AGENDA
PLANNING AND ZONING COMMISSION MEETING
CITY OF CREVE COEUR, MISSOURI
MONDAY, NOVEMBER 16, 2020

1. Application #20-032: Public Facility Site Development Plan Approval for a Building Addition and the Redevelopment of Spoede Elementary School at 425 N. Spoede Road

APPLICATION TO PLANNING AND ZONING COMMISSION
#20-032: PUBLIC FACILITY SITE DEVELOPMENT PLAN APPROVAL FOR A
BUILDING ADDITION AND THE REDEVELOPMENT OF
SPOEDE ELEMENTARY SCHOOL AT 425 N. SPOEDE ROAD

REVISED SITE PLAN PROPOSAL

Figure 1: Close-up of Exhibit 1 submitted on 11/9/2020 showing the existing school drop off configuration.

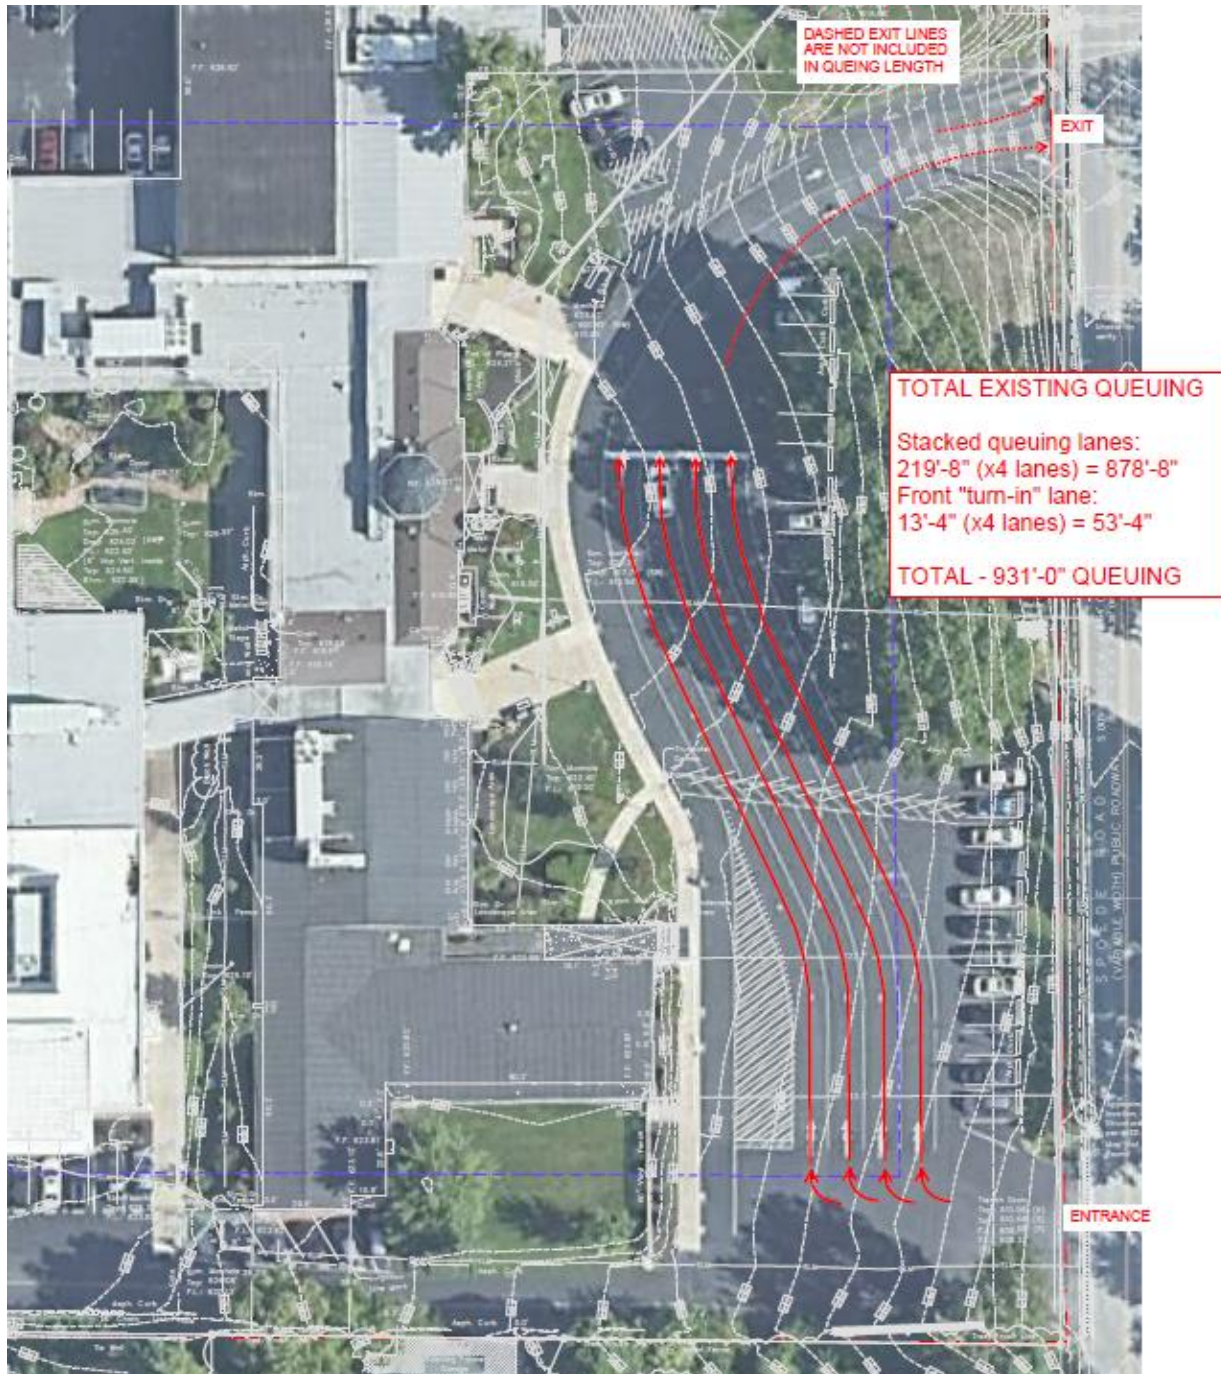
This application was continued by the Planning and Zoning Commission at the November 2, 2020 meeting to provide additional information as requested by the Commission. The Applicants have submitted a revised site development plan to address the prior Staff Report comments and to provide additional information on the stacking lanes to address the Commission's concern with respect to the traffic impacts to Spoede Road. The Applicant's Exhibit 1 shows the existing stacking lanes that total 931 feet of queuing, which is approximately 49 cars accommodated with the existing configuration.

Figure 2: Close-up of Exhibit 2 submitted on 11/9/2020 showing the queuing of the proposed Site Development Plan.

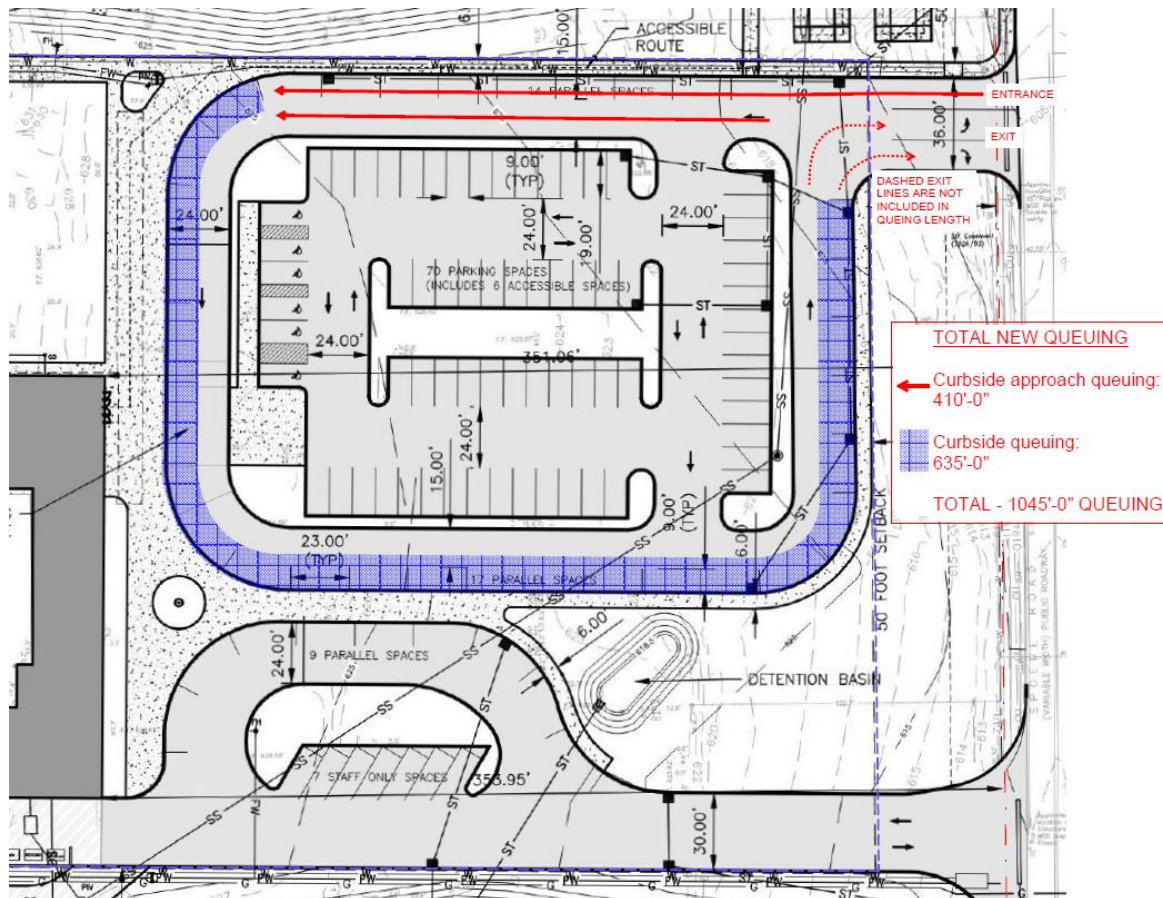
The Applicants have also provided additional information on the morning and afternoon operations. The School has indicated that currently, there are (and there will be in the future) 5-6 staff in the front of the building supervising student arrivals, directing parents to pull as far forward as possible, and helping unload children in a safe manner, and in the afternoon there are approximately 10 staff in front of the building supervising, including one stationed at each site entry and exit controlling traffic.

Figure 5: Close-up of the revised Site Plan Submitted on 11/9/2020

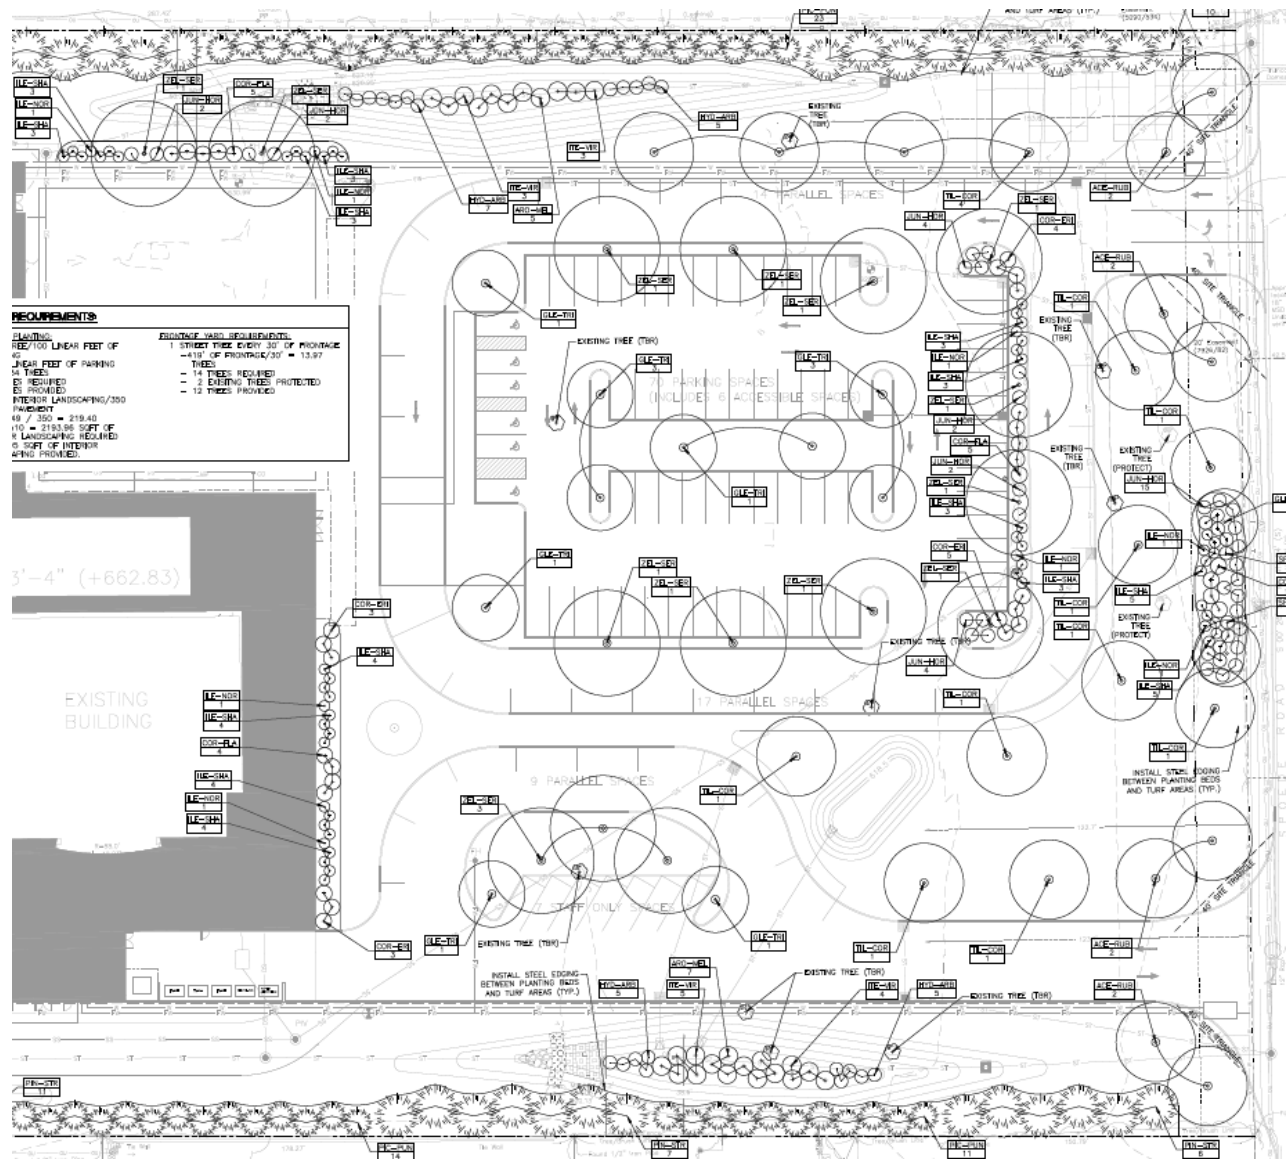
The revised layout for the accessible parking and accessible sidewalk has been reviewed by the Building Division and Department of Public Works and meets with their approval at this stage of design.

Figure 11: Site Development Plan submitted on 10-26-2020.

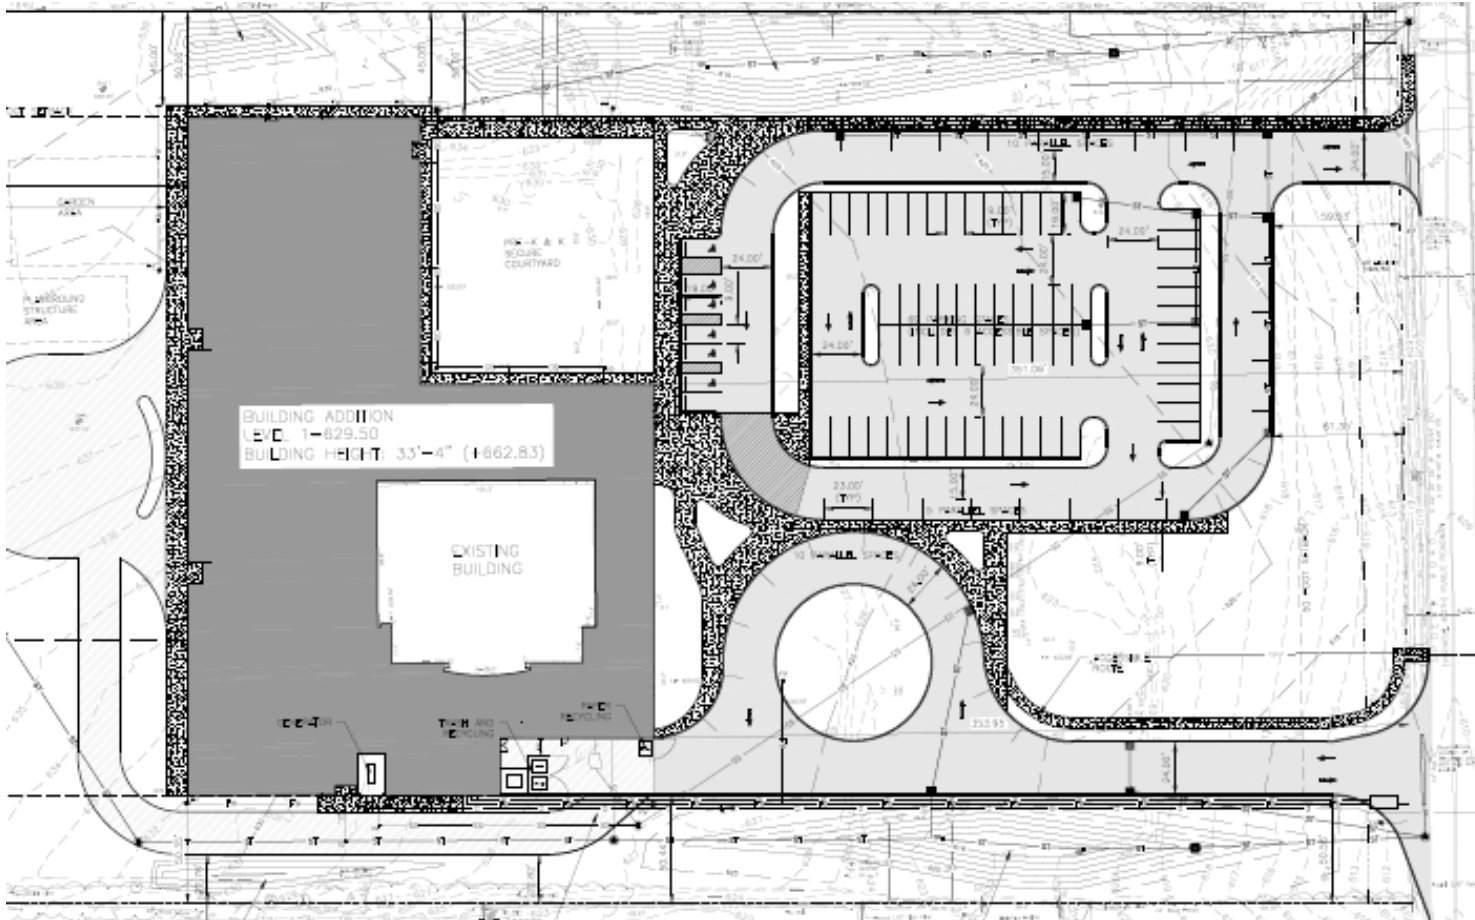
- The encroachments of the access drive to the rear of the building, and the walkways around the building that are within the required 50-foot buffer yard area
- The sidewalks along North Spoede Road and certain areas within the site require modifications.
- The Commission should determine if the overall modern design and layout is compatible with the surrounding area.

Figure 13: Close-up of the Site Development Plan showing the access drive along the south property line.

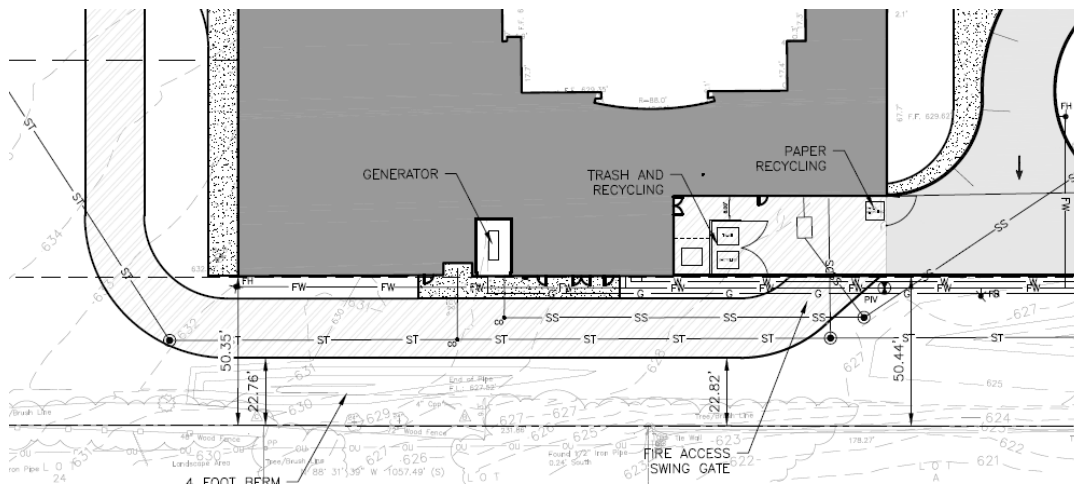
The site is preexisting non-conforming, where the existing parking lot and building are within the buffer yard. The proposed new building will sit behind the existing building, near the center of the site, due to the need to have the school in session while construction will be occurring. Once the new school is built the existing school will be torn down, and the front will become parking and school bus parking. The proposed new building is built to the 50 foot side yards at the north and south, however the walk ways around the building are within the buffer yard, at 45 feet along the north property line, as well as the emergency access drive on the south which is approximately 22.82 and 22.76 feet from the south property line.

While the proposed site plan does not provide for a consistent setback along Spoede Road with the surrounding residential properties, and the service drive is within the recommended landscaped buffer area, the proposal does represent an improvement in other areas over the existing, by decreasing the amount of coverage within the buffer yard, reducing the overall site coverage, and providing enhanced landscaping along N. Spoede Roads, and along the north and south property lines, to screen parking areas and service drive, from the adjacent properties.

Figure 14: Close-up of the Landscape Plan

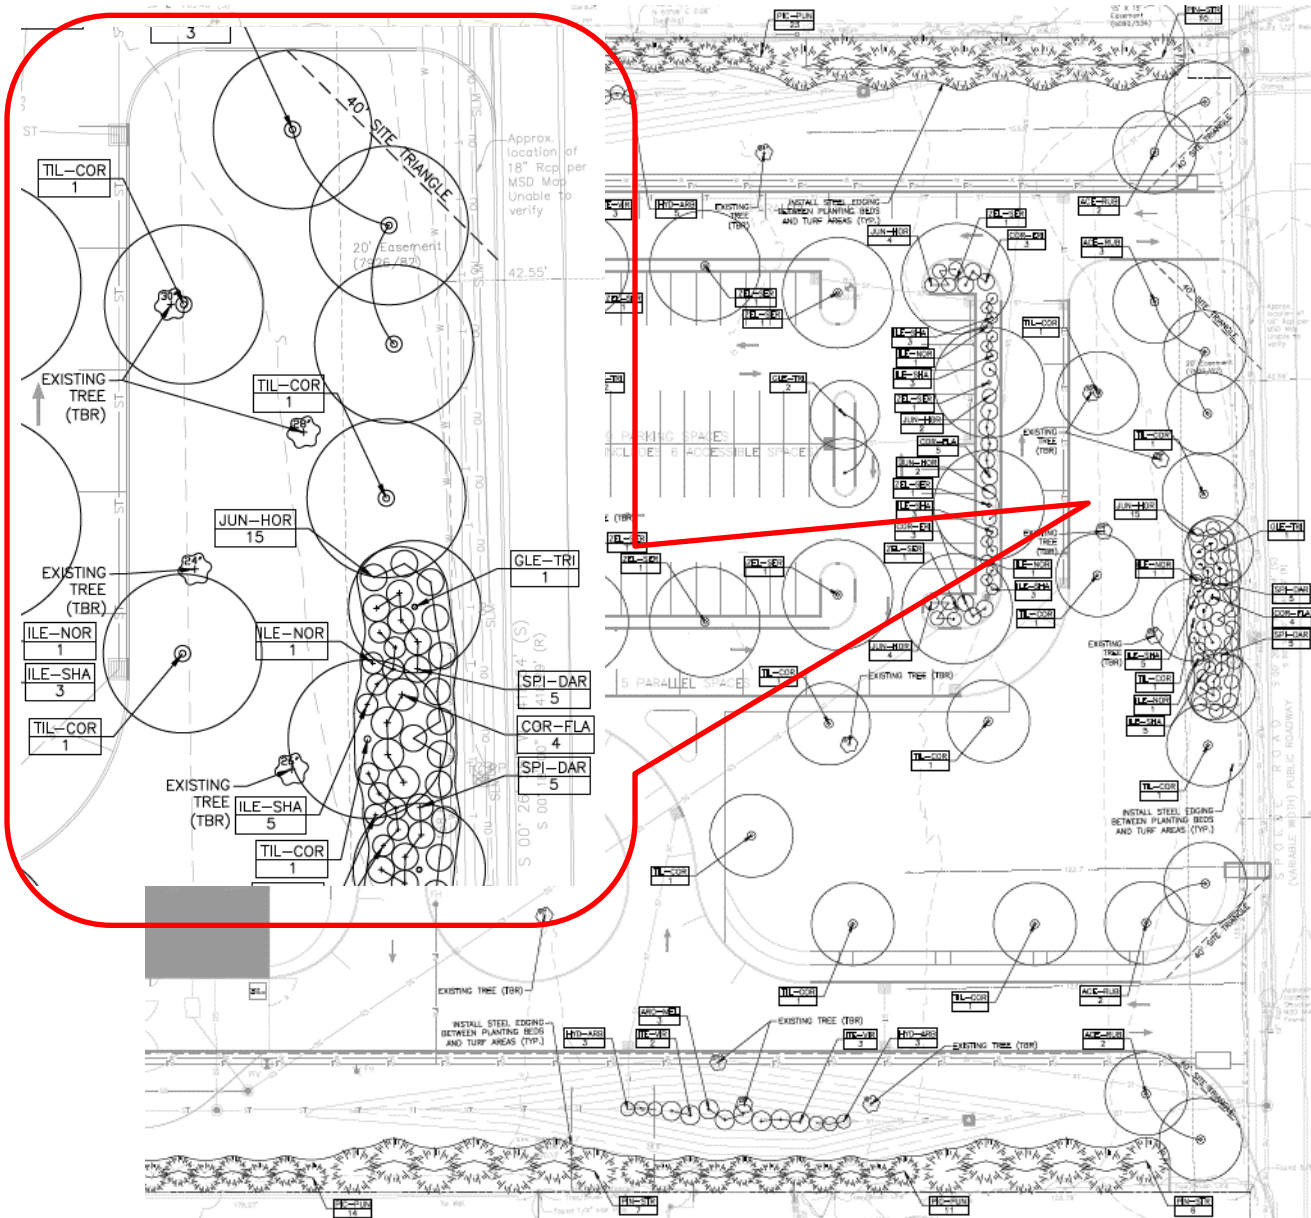
The Design Guidelines also suggest that parking lots need to be broken up into smaller spaces with landscaped pedestrian linkages; and that parking areas located to the side or rear of commercial buildings are encouraged. The proposed layout moves all of the parking to the front, with the building near the center of the site. It is not uncommon for institutional uses within residential districts to have some parking located in front of the building; however, this proposal places all of the parking in front, which is not typical. This is likely a function of the relatively narrow site and required buffers as well as the desire by the school district to construct the new building while the existing building remains functional. The parking located in front is balanced by the proposal providing well landscaped frontages along N. Spoede Road, and along the north and south property lines, and within the parking lots to provide headlight screening of the parking area, and along the access drive. However, the plans do show that the large, 24-30" trees are to be removed, and new trees are to be placed near these areas. Staff would recommend that further consideration be given for these large trees to be protected and maintained within the landscape.

6. The rooftop mechanical screening should be a flat metal to better integrate the material with the building.
7. The Applicant shall provide proper tree protection of the existing tree large caliper trees along Spoede Road and comply with Section 405.540 Landscaping of the Zoning Ordinance.

Figure 18: Site Plan emailed on 10/29/2020 showing the sidewalk extension along Spoede Road. The areas in red indicate where the sidewalks should be extended to coincide with full length of the parking spaces.

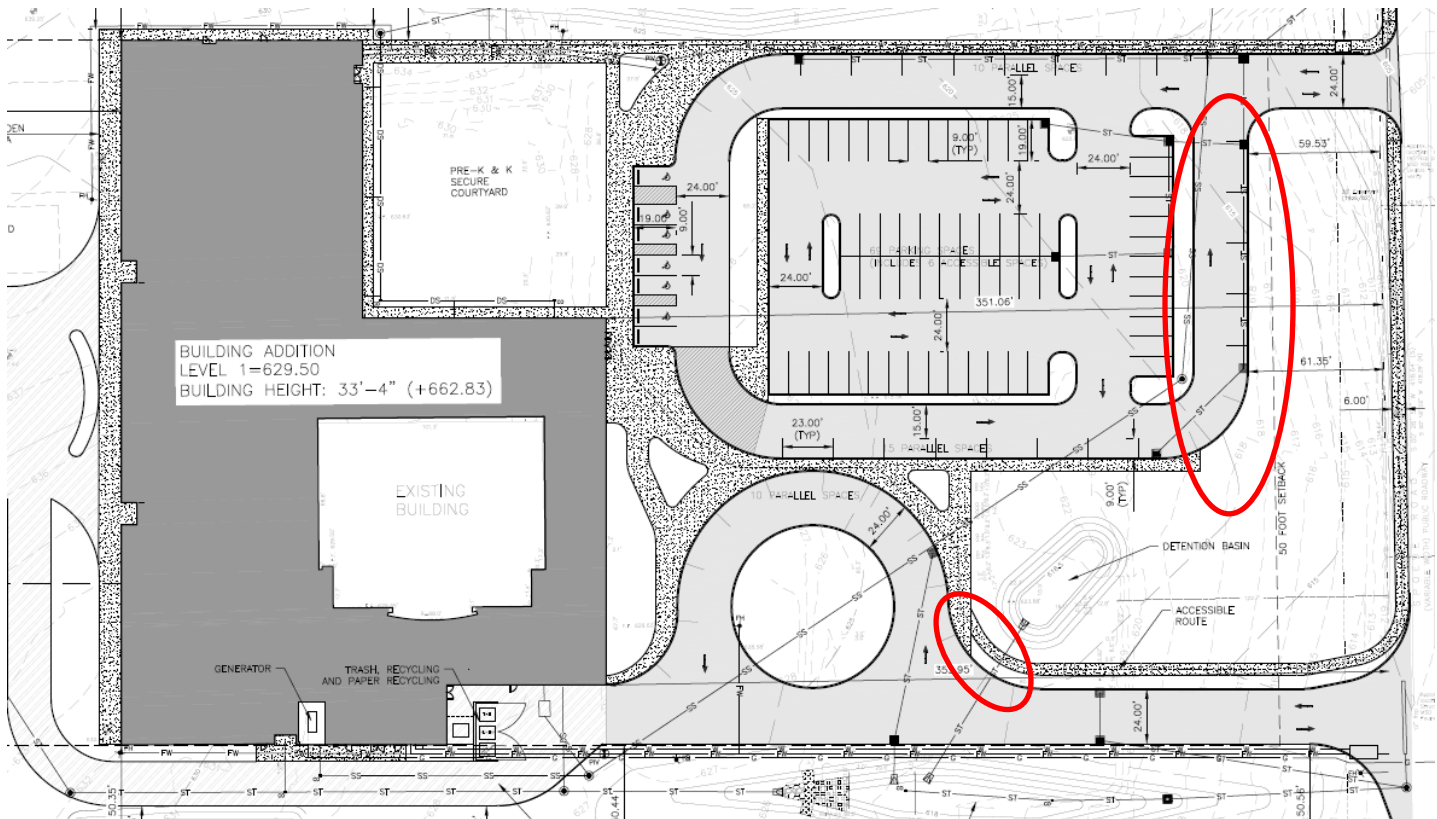
Section 405.730 Sidewalks requires that all internal sidewalks shall be safe, clearly defined and direct, buffered from the street vehicular traffic and parking areas by a minimum of 3 foot greenspace or landscape area, provide safe clearly defined and direct access between buildings from the principal building's entrance to the public side walk, and all internal sidewalks in non-residential developments shall be at least 6 feet in width or 8 feet if used as a curb stop, and the use of textured or tinted materials for pedestrian crossings shall be utilized where pedestrian circulation paths cross a vehicular route. All sidewalks within the parking area are shown at 9-feet in width, but in other areas, the internal sidewalk is 5-feet in width with greenspace separation from the road and drive aisles. The site plan submitted on October 26, 2020, indicated that the accessible walkway was located along the south entrance. A revised Site Plan was emailed on October 29, 2020, to show that a 6-foot-wide sidewalk adjacent to the curb

along the west side of Spoede Road is extended the public sidewalk southward to the new walkway. However, this area has utility poles near the curb line, and therefore the sidewalk will need to be beyond these utility poles. Therefore, Staff has included a condition that all sidewalks are to be a minimum of 6 feet in width, and that the sidewalk along N. Spoede Road should be separated from the curb to avoid the utility poles. Public Works has requested that the sidewalk be extended across the southern entrance with a ramp at the south property line and that all sidewalks along N. Spoede Road are to be placed within an easement. Additionally, the internal sidewalks within the parking areas should be extended to the full length of the parallel parking, as shown in Figure 18. Staff has provided conditions to address all of the recommended sidewalk revisions for staff approval as part of the permit review.

4. The sidewalk along N. Spoede Road to the accessible pathway at the south entrance shall follow the configuration as shown on the revised Site Plan emailed on October 29, 2020, subject to the following revisions: the sidewalk is to be detached from the curb and placed on the property side of the existing utility poles, located within an easement granted to the City for public use and maintenance, and be extended across the southern entrance with a ramp on the south side subject to final approval by the Public Works Department.
